Louisiana Energy Services, L. P.  
National Enrichment Facility  
NRC Docket No. 70-3103

**Subject:** Response to NRC Request for Additional Information Regarding the National Enrichment Facility Environmental Report

**Louisiana Energy Services  
Response to April 29, 2004,  
Request for Additional Information**

Figure ER RAI 2-1

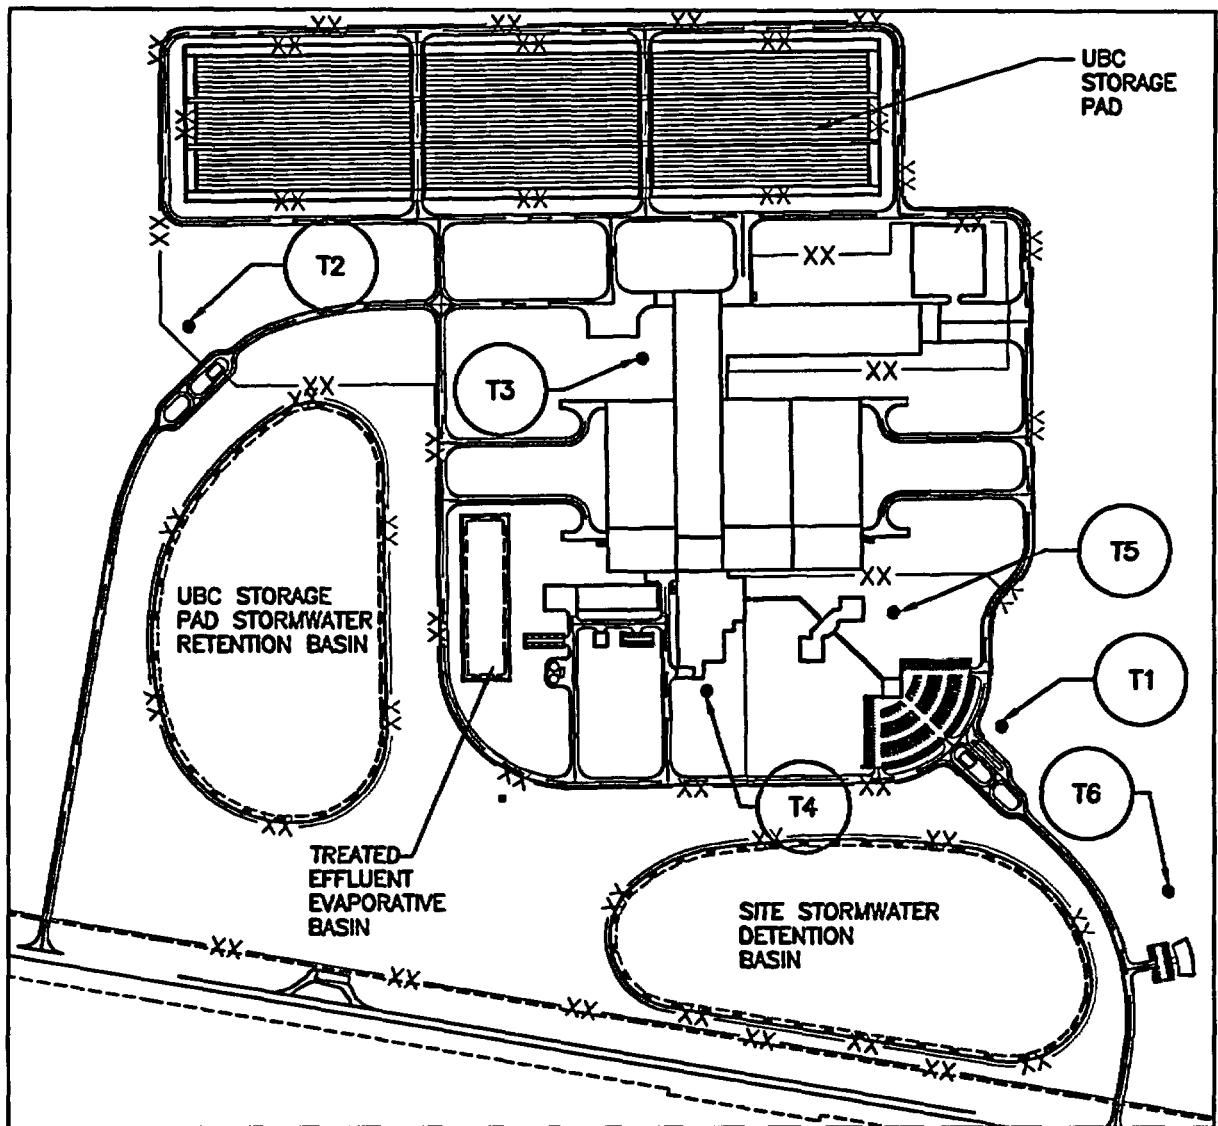
Provide a map or a figure to show the current CO<sub>2</sub> line location through the proposed NEF.

- Sections 2.1.2.1, 2.1.2.5, 4.1.1, and 4.1.2. state that the Trinity Pipeline, LLC, 10-in diameter, 2000 psi, underground CO<sub>2</sub> pipeline traverses southwest to northwest across the proposed NEF and would be re-routed but no maps show the current location of the pipeline.

The current location of the CO<sub>2</sub> pipeline is provided on Figure ER RAI 2-1, "Location of Current CO<sub>2</sub> Line," in Attachment 3 to this submittal. As shown in this figure and stated in ER Sections 2.1.2.1 and 2.1.2.5, the pipeline runs southeast-northwest, across the NEF site.

FIGURE ER RAI 2-2

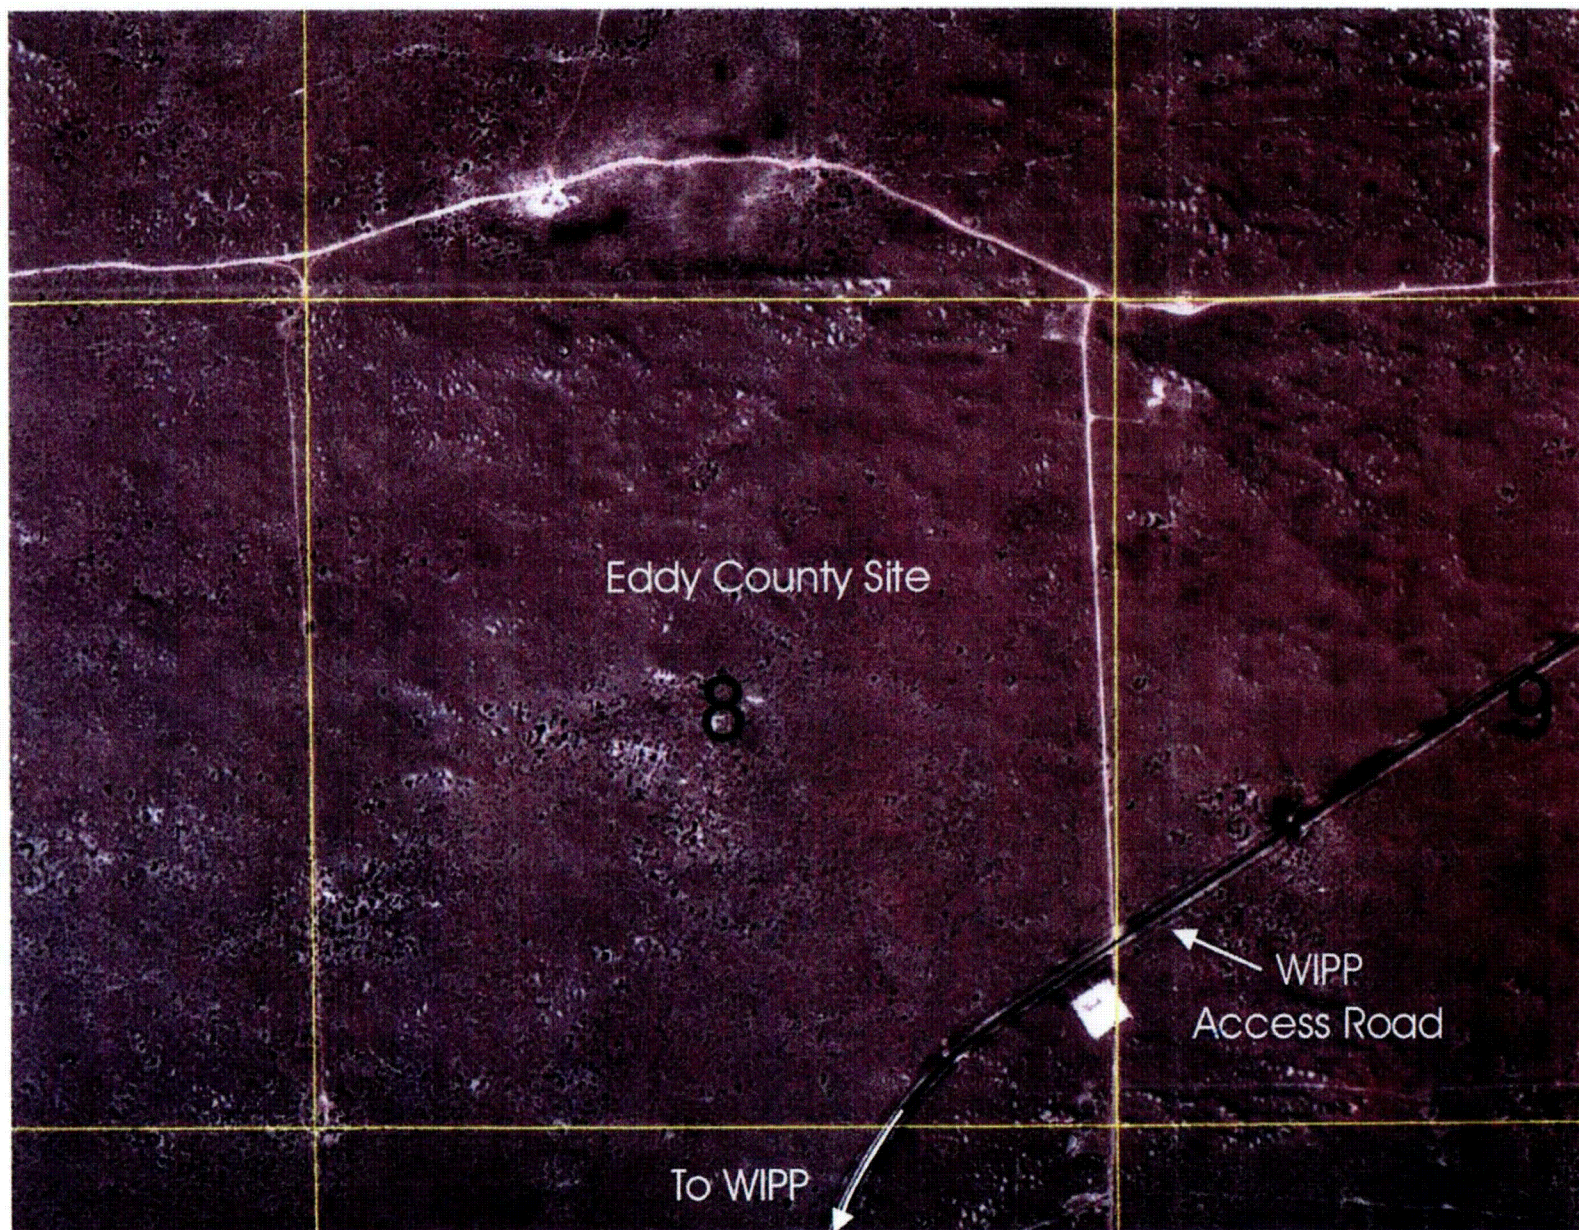
Provide a detailed description of the septic tanks and leach fields.

The design approach for disposal of sanitary wastes has been modified since the submittal of the ER. LES will incorporate a detailed description of the NEF septic systems in the next revision to the ER. Six septic systems are now planned in lieu of three septic tanks with a common leachfield. Each septic system will consist of a septic tank with one or more leachfields. Refer to Figure ER RAI 2-2, "Planned Septic Tank System Locations," in Attachment 3 to this submittal for the planned location of the six septic tank systems.

Figure ER RAI 2-7C.1

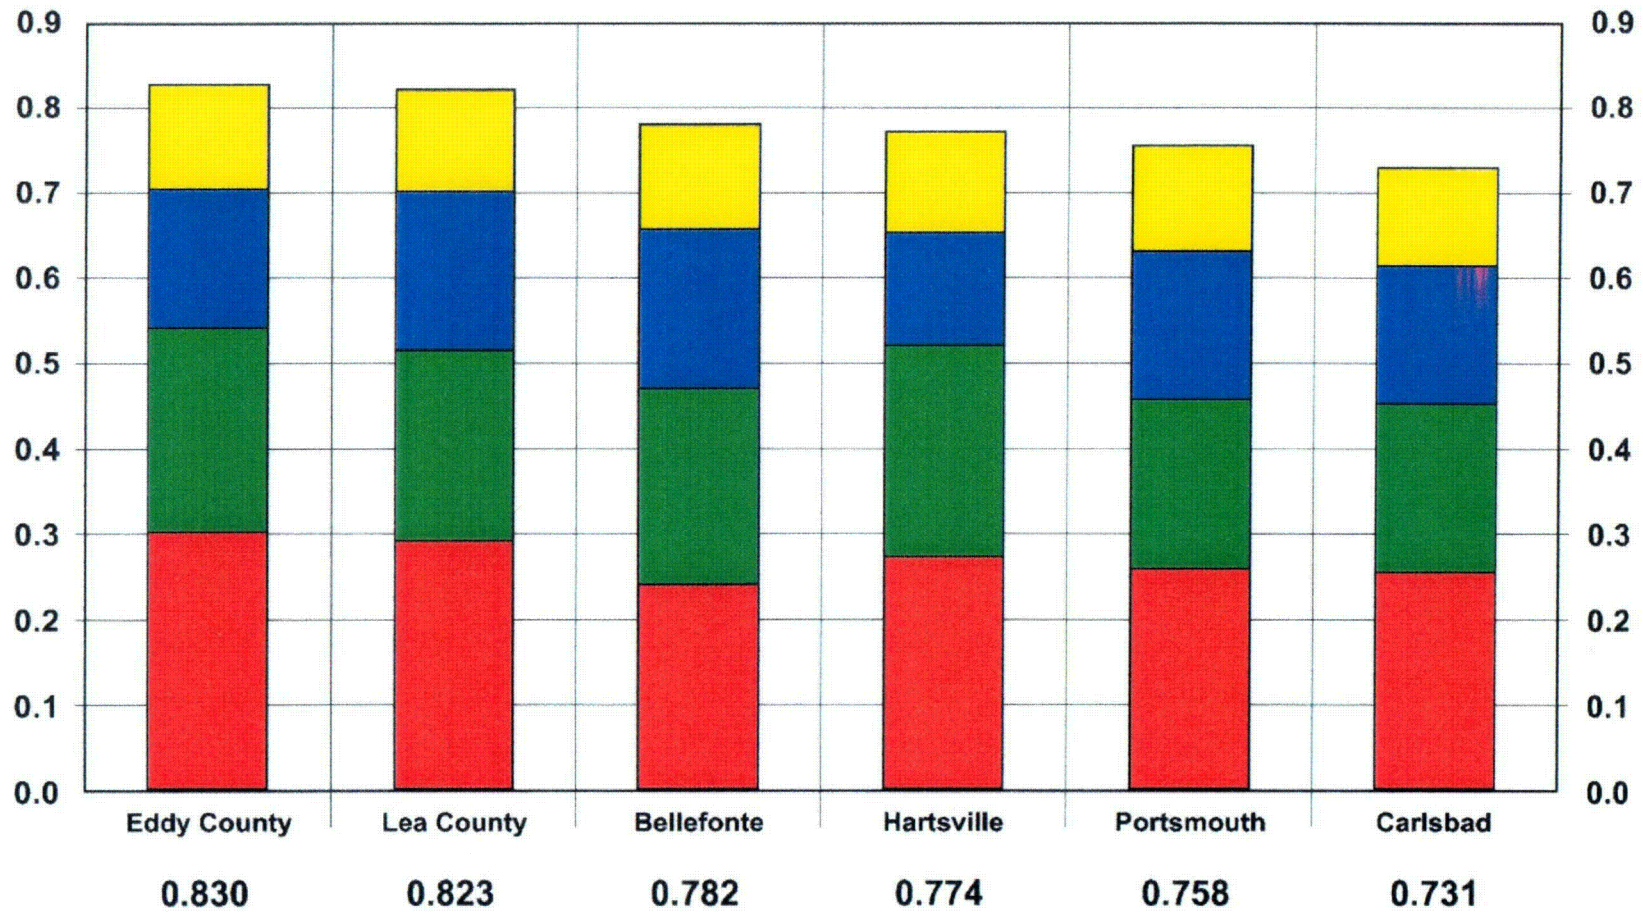
- C. Verify that the description of the Eddy County site is accurate in Section 2.1.3.3.4.2.
- The written description of the location of the Waste Isolation Pilot Plant (WIPP) access road and utilities indicate that the correct site is Section 11 of Township 22S, Range 31E of the New Mexico Meridian which is northeast of the current WIPP site. Section 2.1.3.3.4.2 identifies the Eddy County site as Section 8 of Township 22S, Range 31E of the New Mexico Meridian which is near the northwest corner of the WIPP site.

- C. The description of the Eddy County site in ER Section 2.1.3.3.4.2 is correct. Figure ER RAI 2-7C.1, "Aerial View of Eddy County Site," in Attachment 3 to this submittal provides an aerial view of the Eddy County site. As described in Section 2.1.3.3.4.2 and as shown on Figure ER RAI 2-7C.1, the main WIPP access road is on the southeastern edge of the site.

CONTRIBUTIONS  
BY  
GROUPED CRITERIA

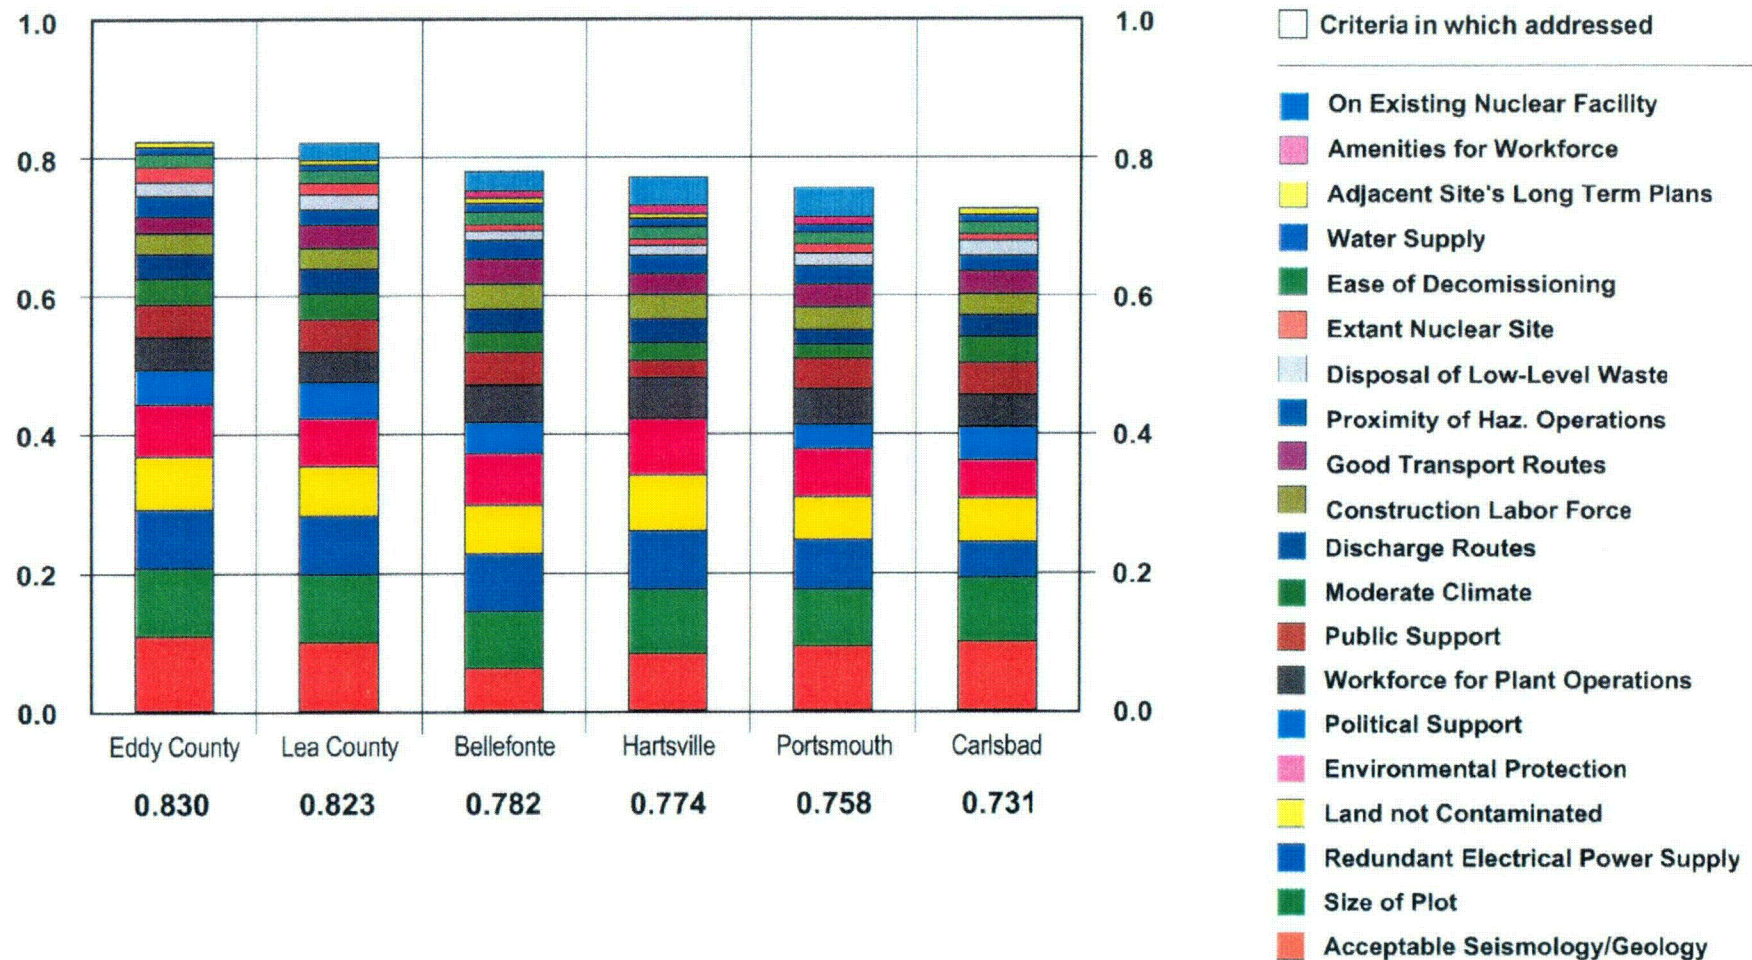
- A. Provide a sample calculation to allow the NRC to reproduce the site score results in Section 2.1.3.3.3.
- In Section 2.1.3.3.3, a summary is provided on how the site scores are calculated. Table 2.1-9 summarizes the unweighted scores of the sites against the second phase screening criteria. Figures 2.1-7 and 2.1-8 present the final weighted scores.

- D. Figures ER RAI 2-7D.1, "Contributions by Grouped Criteria," and ER RAI 2-7D.2, "Contributions by Criteria," in Attachment 3 to this submittal include the final weighted scores for the six sites, including Portsmouth. LES will revise ER Figures 2.1-7 and 2.1-8 to be consistent with Figures ER RAI 2-7D.1 and ER RAI 2-7D.2 in the next revision to the ER.

## Comparison of WCS and Midland-Odessa Wind Direction Data

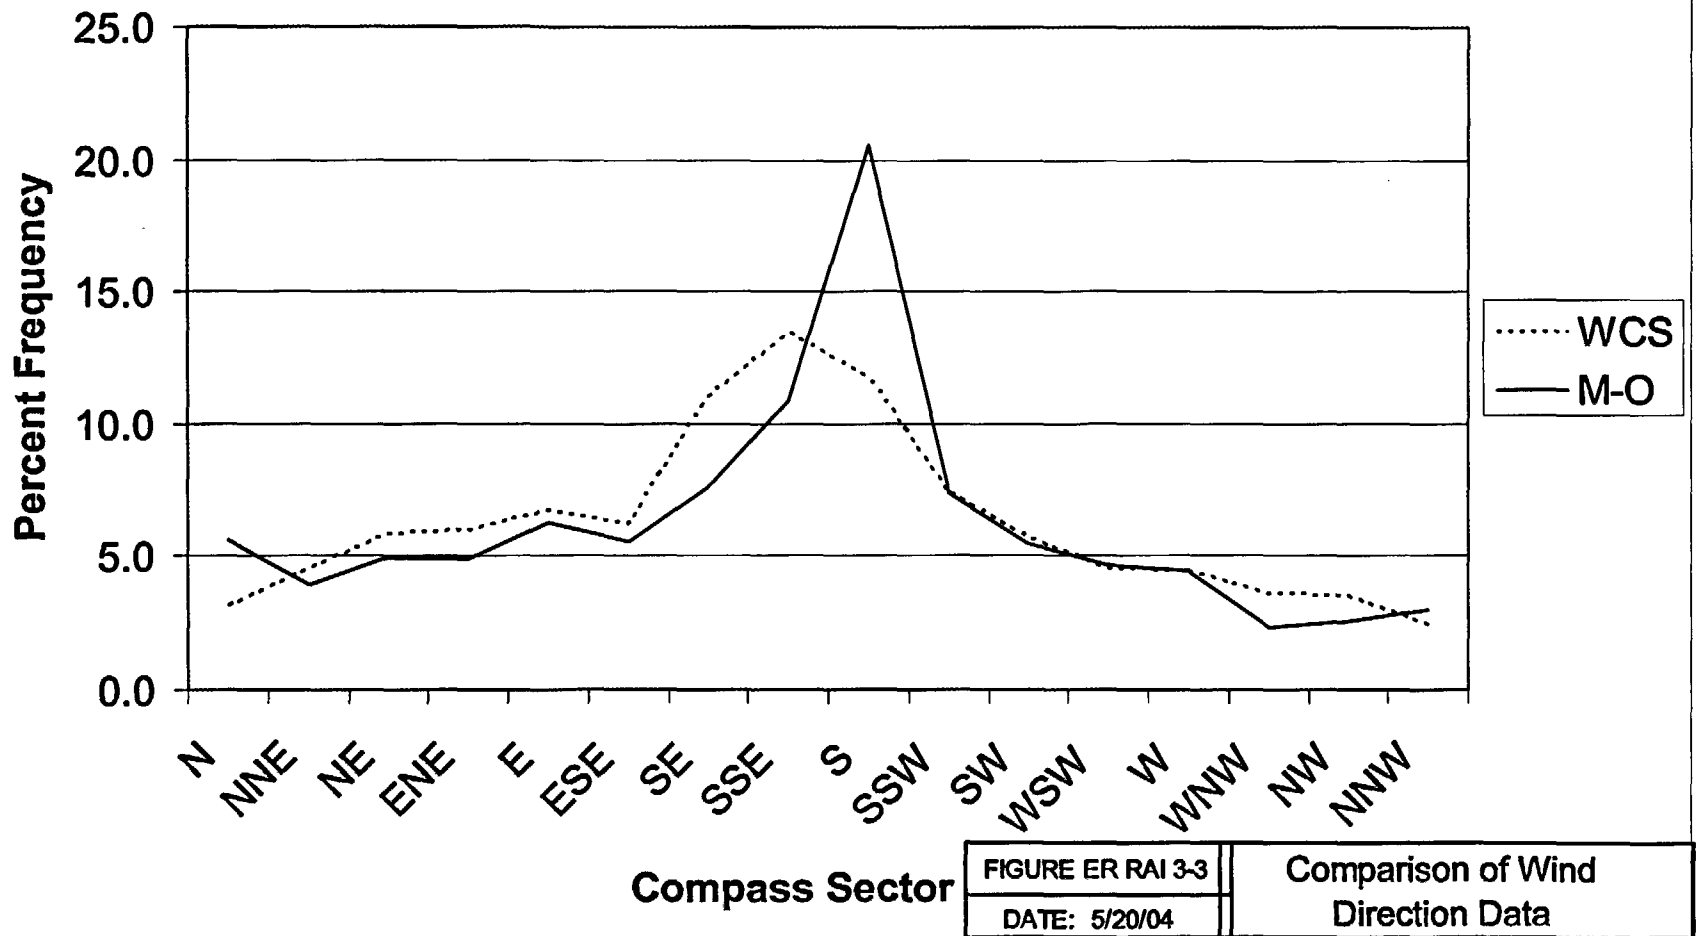
Provide the correlation analyses of the meteorological data from the Midland-Odessa, Texas Airport with the Waste Control Specialists (WCS) meteorological data.

As shown in Table ER RAI 3-3.1, the prevailing wind direction has a southerly component at both sites. Figure ER RAI 3-3, "Comparison of Wind Direction Data," provided in Attachment 3 to this submittal, provides a graphical comparison of the WCS and the Midland-Odessa wind direction frequency distribution. A comparison of the WCS and Midland-Odessa data provided in Table ER RAI 3-3.1 and in Figure ER RAI 3-3 shows good agreement in wind direction frequency between the two sites even though the meteorological data are from different time periods and the two sites are separated in distance and are at different elevations.
